Report of the LARP/HL-LHC International Review of the Superconducting Cables for the HL-LHC Inner Triplet Quadrupoles (MQXF)

held at CERN, 5 – 6 November, 2014

International Review of the Superconducting Cables for the HL-LHC Inner Triplet Quadrupoles (MQXF)

Bruker PIT strand, 192

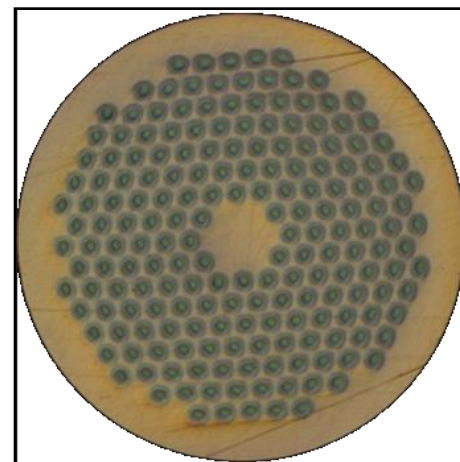
- In view of the crucial [2-supplier policy](#) at CERN that is essential for this project and beyond, the panel highly recommends a substantive support program for the PIT wire to further optimize strand properties and establish performance baseline for series production.
- In the meantime, CERN [should go ahead with RRP](#) strands and cabling for its model magnet production and should optimize phasing of strand and cable deliveries between RRP and PIT in order to create maximum flexibility for using the best possible PIT wire and coping with delivery delays.
- In support of the above, [define a clear timeline for the decision making process regarding PIT wire development and production](#).
- Reducing the cable keystone angle in the PIT based cables from 0.55° to 0.40° is a must in order to avoid unnecessary performance risk.
